**AGENDA**  
**BIRMINGHAM DESIGN REVIEW BOARD**  
**WEDNESDAY JULY 19, 2023**  
**BIRMINGHAM CITY HALL, 151 MARTIN ST, COMMISSION ROOM 205, BIRMINGHAM MI \***  
**\*\*\*\*\* 7:15 PM\*\*\*\*\***

**DATE:** July 19, 2023  
**TO:** Design Review Board  
**FROM:** Nicholas Dupuis, Planning Director  
**SUBJECT:** 33202 Woodward – Design Review

**DATE:** July 19, 2023  
**TO:** Design Review Board  
**FROM:** Nicholas Dupuis, Planning Director  
**SUBJECT:** 220 Park St. – Design Review

## Enlarged Plans

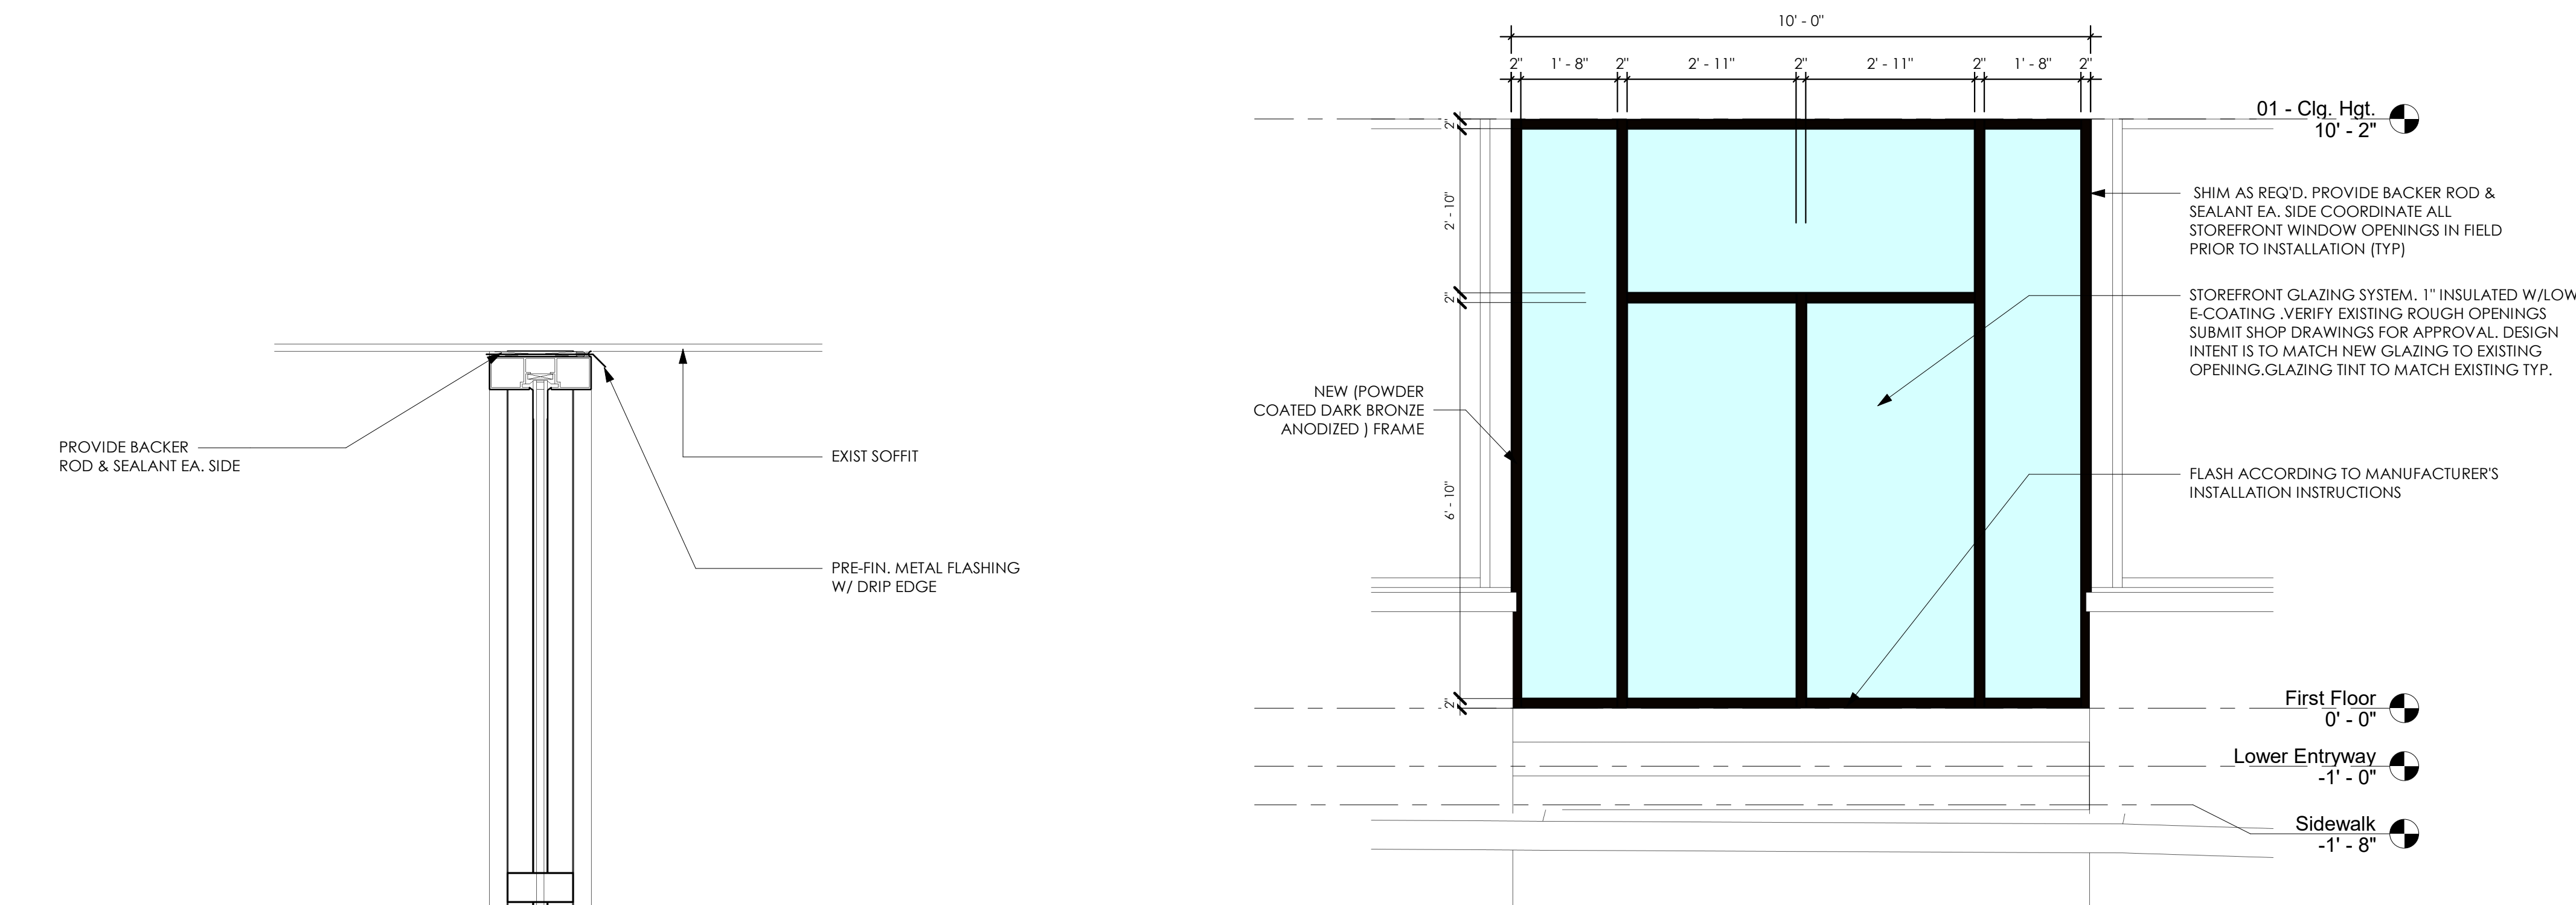
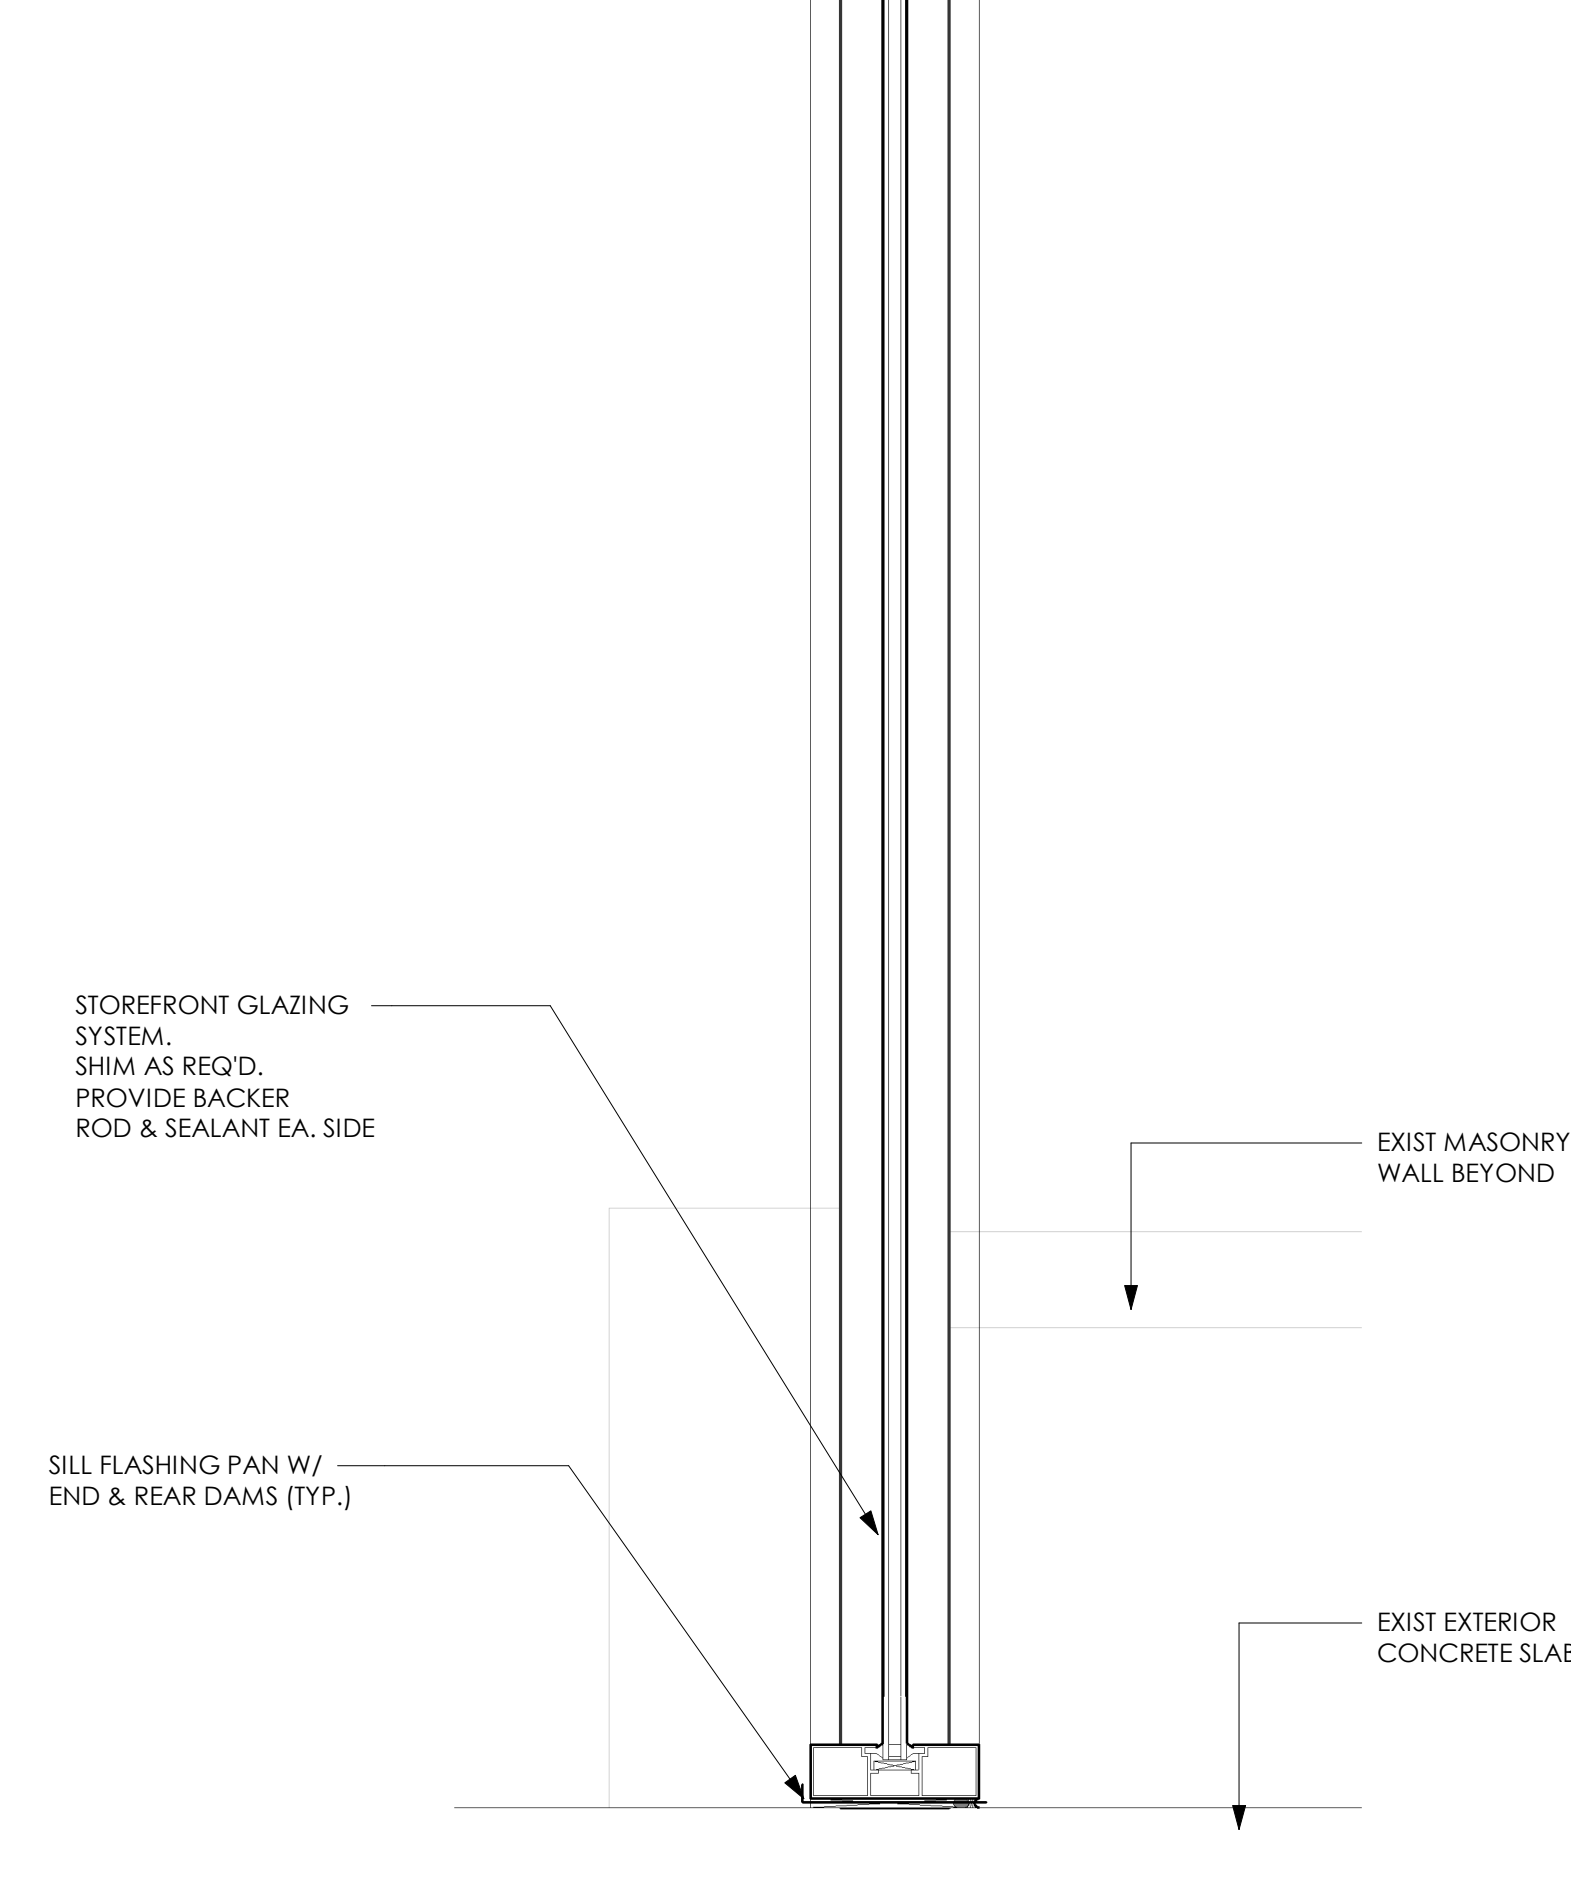
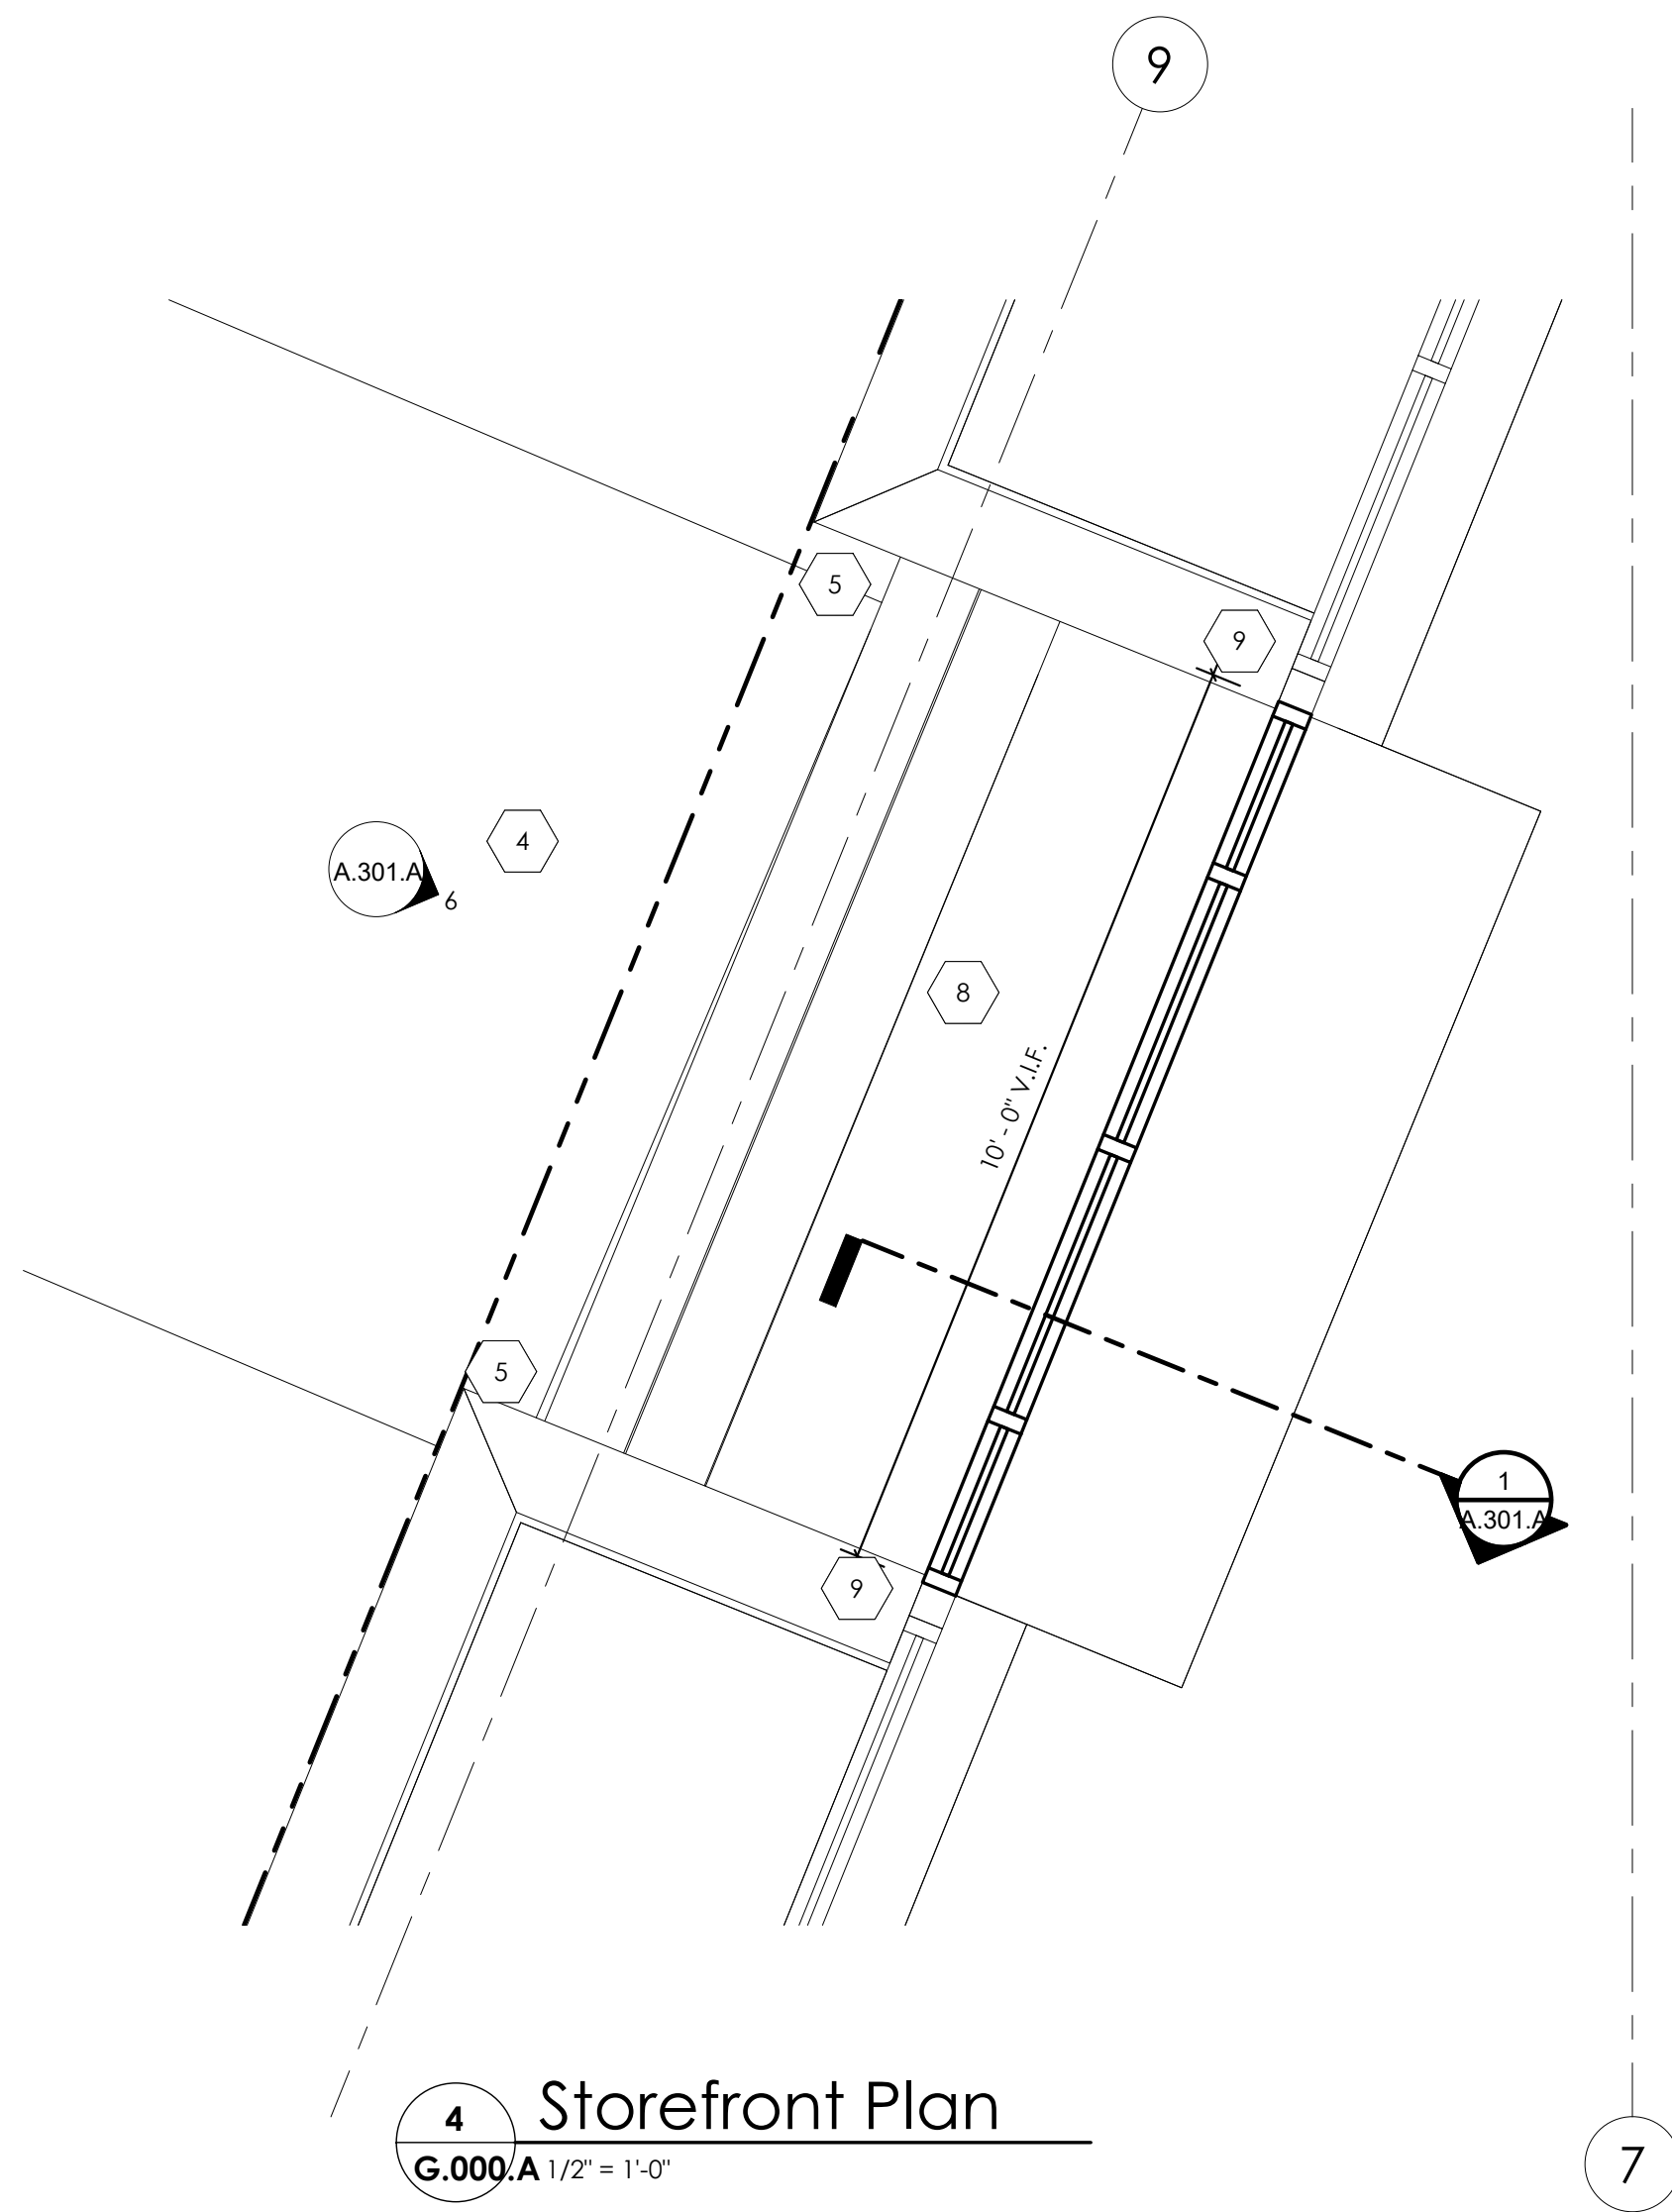
- Glazing – The applicant has indicated that the existing storefront glazing system at the entrance will be replaced. As noted above, the applicant is required to maintain 70%

transparency on the storefront façade and no more than 35% transparency on the upper stories. Although the applicant has not submitted glazing calculations for the storefront facades or the upper story facades, it is clear that the applicant does not meet the storefront glazing requirements. The current condition at the storefront is considered legal non-conforming and may be allowed to continue, as the applicant is not proposing to expand the non-conformity.

The issue at hand, in the opinion of the Planning Division, is that the proposed infill of an existing entrance removes the only ingress/egress point on the entire roughly 110 ft. Hamilton Row frontage line. Although the applicant is proposing to keep the exterior stairs, which will mimic the existing conditions, users of the building will be forced to walk around the block to the Park St. entrance to access the building and its tenants. The Planning Division cites Article 3, Section 3.04 (E)(4) which states that "Storefronts shall be directly accessible from public sidewalks."

Based on the requirements of Article 7, Section 7.09, the Planning Division recommends that the Design Review Board **DENY** the Design Review application for 220 Park. The application does not meet the standards for Design Review and will create a poor urban condition along Hamilton Row.
